# UNITED STATES PATENT AND TRADEMARK OFFICE

APPLICATION NO.	FILING DATE	FIRST NAMED INVENTOR	ATTORNEY DOCKET NO.	CONFIRMATION NO.
10/608,870	06/27/2003	Mark T. Bohr	42P15335	7488
8791	7590	04/05/2005	EXAMINER	
BLAKELY SOKOLOFF TAYLOR & ZAFMAN 12400 WILSHIRE BOULEVARD SEVENTH FLOOR LOS ANGELES, CA 90025-1030			TRAN, LONG K	
			ART UNIT	PAPER NUMBER
			2818

<b>Office Action Summary</b>	<b>Application No.</b> 10/608,870	<b>Applicant(s)</b> BOHR ET AL.	
	<b>Examiner</b> Long K. Tran	<b>Art Unit</b> 2818

**FIG. 3G**

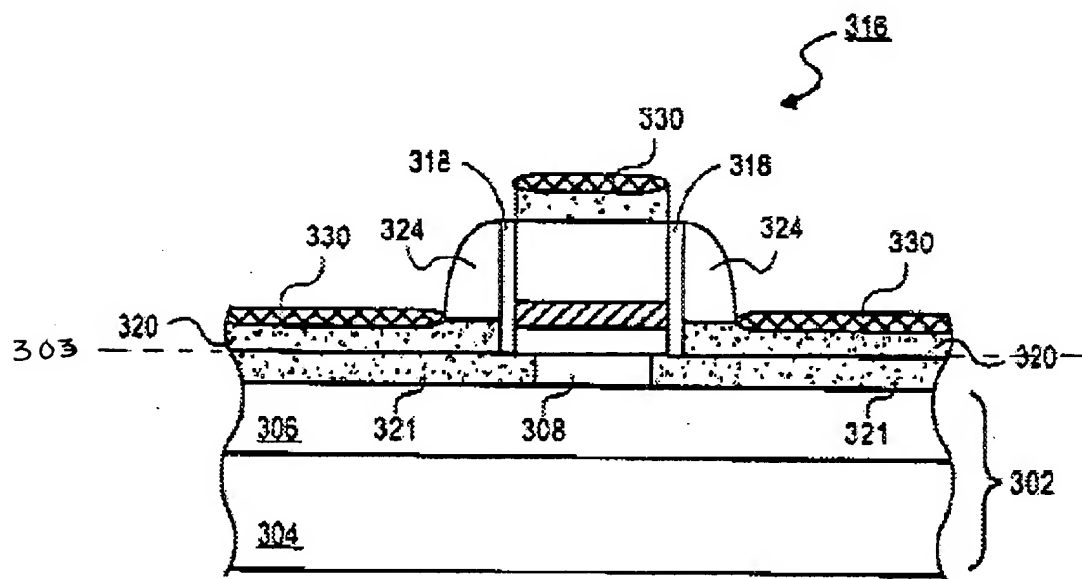
8. Claims **1, 2, 8, 10, 11** and **25** are rejected under 35 U.S.C. 102(e) as being anticipated by Chau et al. (US Patent no. 6,653,700).
9. Regarding claim **1**, Chau discloses a apparatus comprising:
  - a substrate 302 (fig. 3G; col. 4, lines 53, 54 and 55);
  - a device including a gate electrode 316 (fig. 3G; col. 5, lines 45 and 46) on a surface of the substrate and a first junction and the second junction 321 (fig. 3G; col. 7,

lines 50 – 53; note: substrate surface 303 (labeled by the examiner) identical to 203 (fig. 2); col. 3, lines 45 – 47) in the substrate adjacent to the gate electrode 316 (fig. 3G; col. 5, lines 46 and 46); and

an epitaxial layer 320 (fig. 3G; col. 6, lines 45 – 47) comprising silicon alloy disposed in each of the first junction and second junction such that a surface of the first junction region 330 (fig. 3G) and a surface of the second junction region 330 (fig. 3G) are in non-planar relationship with surface 303 of the substrate.

Regarding claim 2, Chau discloses a surface 303 (fig. 3G) of the substrate defines a top surface of the substrate and the surface of the first junction region 330 (fig. 3G) and the surface of the second junction region 330 (fig. 3G) are superior to the top surface of the substrate (fig. 3G).

Regarding claim **8**, Chau discloses a surface of the substrate proximate to the first junction region defines a first substrate sidewall surface and a surface of the substrate proximate to the second junction region defines a second substrate sidewall surface 318 (fig. 3G) and the silicon alloy material 320 (fig. 3G) disposed in the first junction region is attached to the first substrate sidewall surface and the silicon alloy material disposed in the second junction region is attached to the second substrate sidewall surface 318 (fig. 3G).

Regarding claim **11**, Chau discloses a layer 330 (fig. 3G; col. 8, lines 53 and 62) of silicide material on the surface of the first junction region, the surface of the second junction region, and the gate electrode, wherein the layer of silicide material comprises titanium silicide (col. 8, line 62).

a device including a gate electrode 316 (fig. 3G; col. 5, lines 45 and 46) on a surface of the substrate and a first junction and the second junction 321 (fig. 3G; col. 7, lines 50 – 53; note: substrate surface 303 (labeled by the examiner) identical to 203 (fig. 2); col. 3, lines 45 – 47) in the substrate adjacent to the gate electrode 316 (fig. 3G; col. 5, lines 46 and 46); and

an epitaxial layer 320 (fig. 3G; col. 6, lines 45 – 47) comprising silicon alloy disposed in each of the first junction and second junction such that a surface of the first

junction region 330 (fig. 3G) and a surface of the second junction region 330 (fig. 3G) are in non-planar relationship with surface 303 of the substrate. Wherein the silicon alloy material has one of the same crystallographic characteristic, a same crystal structure, and a same crystal grade as the substrate (note: the substrate in Chau's device is a monocrystalline (col. 4, lines 49+) similar to the claimed substrate; the silicon alloy in Chau's device is a single crystalline silicon (epitaxial silicon) (col. 7, lines 9 – 15) similar to the claimed silicon alloy layer, therefore, the silicon alloy material in Chau's device has one of the same crystallographic characteristic, a same crystal structure, and a same crystal grade as the substrate).

a silicon alloy material layer 320 (fig. 3G; col. 6, lines 45 – 47) disposed in each of the first junction and second junction such that a surface of the first junction region 330 (fig. 3G) and a surface of the second junction region 330 (fig. 3G) are superior to the top of the surface 303 of the substrate by a length  $s_a$  discussed in claim 3 above.
